Project	IEEE 802.16 Broadband Wireless Access Working Group < http://ieee802.org/16 >	
Title	Relay Path Management during Network Entry	
Date	2007-04-23	
Submitted		
Source(s)	Kanchei (Ken) Loa, Yi-Hsueh Tsai, Yung-Ting Lee, Chih-Chiang Hsieh, Hua-Chiang Yin, Shiann-Tsong Sheu, Frank C.D. Tsai, Youn-Tai Lee, Heng-Iang Hsu Institute for Information Industry 8F., No. 218, Sec. 2, Dunhua S. Rd., Taipei City, Taiwan.	Voice: +886-2-2739-9616 loa@iii.org.tw
	[add co-authors here]	
Re:	IEEE 802.16j-07/013:"Call for Technical Comments Regarding IEEE Project 802.16j"	
Abstract	This contribution proposes modifications on 6.3.25.2.1	
Purpose	Text proposal for 802.16j Baseline Document	
Notice	This document has been prepared to assist IEEE 802.16. It is offered as a basis for discussion and is not binding on the contributing individual(s) or organization(s). The material in this document is subject to change in form and content after further study. The contributor(s) reserve(s) the right to add, amend or withdraw material contained herein.

Relay Path Management during Network Entry

(Comments on 6.3.25.2.1 Path Establishment, Removal and Update)

Example 1a: RS1 entering the MR-BS network directly

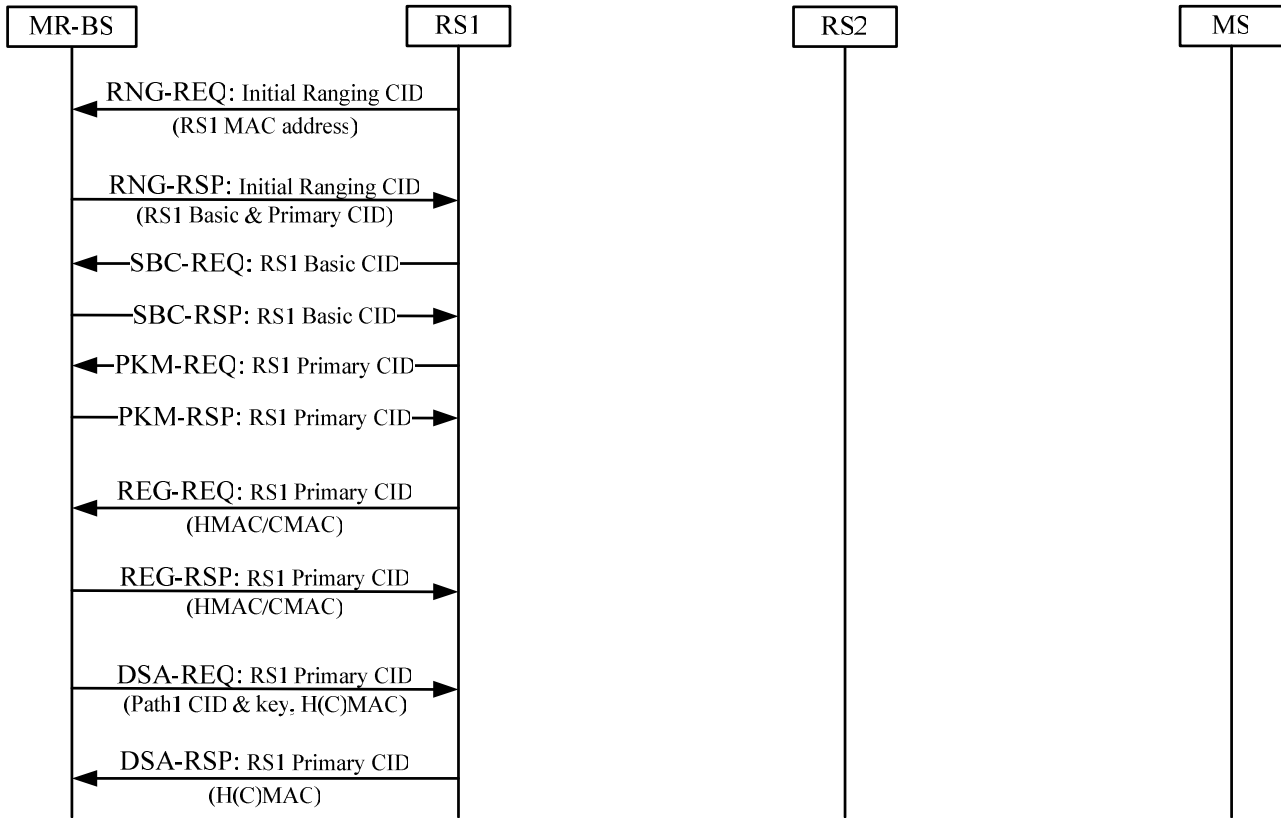
In the MS/RS network entry phase, because the MR-BS shall send the RNG-RSP with success status to the new RS via the selected relay path to complete the ranging process, it is more efficient to piggyback the RNG-RSP message with additional TLVs as the path establishment command instead of using extra DSA/DSD*-REQ messages. In order to elaborate the proposed light-weight relay path management scheme, an example is given as follows, which depicts the path establishment flows of a 3-hop MR network. Moreover, to facilitate the incorporation of this proposal into IEEE 802.16j standard, specific changes to the baseline working document IEEE 802.16j-06/026r3 are listed below.
